Subject: MHI's Responses to US-APWR DCD RAI No. 459-3331

Reference: 1) "Request for Additional Information No. 459-3331 Revision 1, SRP Section: 03.06.02 – Determination of Rupture Locations and Dynamic Effects Associated with the Postulated Rupture of Piping, Application Section: 3.6.2," dated 9/16/2009.

Responses to Request for Additional Information No. 459-3331,
Revision 1

RAI NO.: NO. 459-3331 REVISION 1
SRP SECTION: 03.06.02 – Determination of Rupture Locations and Dynamic Effects Associated with the Postulated Rupture of Piping
APPLICATION SECTION: 3.6.2
DATE OF RAI ISSUE: 09/16/2009

Figure 1 CVCS Piping Penetration Area

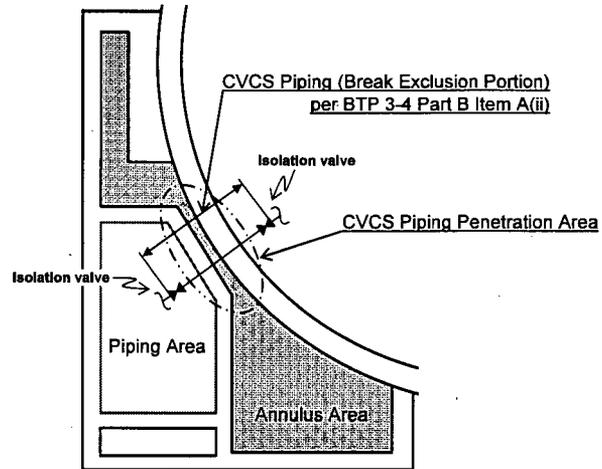
In its response to RAI 03.06.02-8, MHI stated that since the PCCV penetrations are isolated in compartments made of concrete, guard pipes are not considered necessary around the PCCV penetrations. Therefore, it is not considered necessary to apply criteria of guard pipe, BTP 3-4 Part B Item A(ii)(3) and A(ii)(6) for this room. However, it appears to the staff that the guard pipe assembly is functionally similar to the piping penetration compartment (or sleeve) indicated in the DCD and MHI did not address the staff's concern described in the original RAI. Therefore, the applicant is requested to clarify whether conditions specified in BTP 3-4, Part B, Items A(ii)(3) and (6) are applicable to the design of piping penetrations shown in DCD Figure 3.8.1-8 or provide the design criteria for these piping penetrations.

The annulus area is composed of several closed compartments surrounding the prestressed concrete containment vessel (PCCV). The high energy piping penetrating the PCCV is main steam, feedwater, steam generator blowdown, and chemical and volume control system (CVCS) piping. The high energy piping runs from the PCCV through the annulus to the piping area, which is isolated in a compartment made of concrete, is shown in Figure 1. The high energy piping has an isolation valve in the piping area. Therefore, the portion of the high energy piping passing through the annulus is not necessary to postulate pipe break due to satisfying pipe break exclusion criteria specified by BTP 3-4 Part B Item A(ii). Specifically, this portion passing through this area is designed with stress limitation, no weld attachment, minimization of welding, and 100% volumetric in-service examination is carried out for welding. Therefore guard pipes are not considered necessary for high energy piping penetrating the PCCV.

The moderate energy piping is also passing through the annulus. The postulated leakage crack of the moderate energy piping will not cause significant pressurization. Therefore, guard pipes are also not considered necessary for moderate energy piping penetrating PCCV.
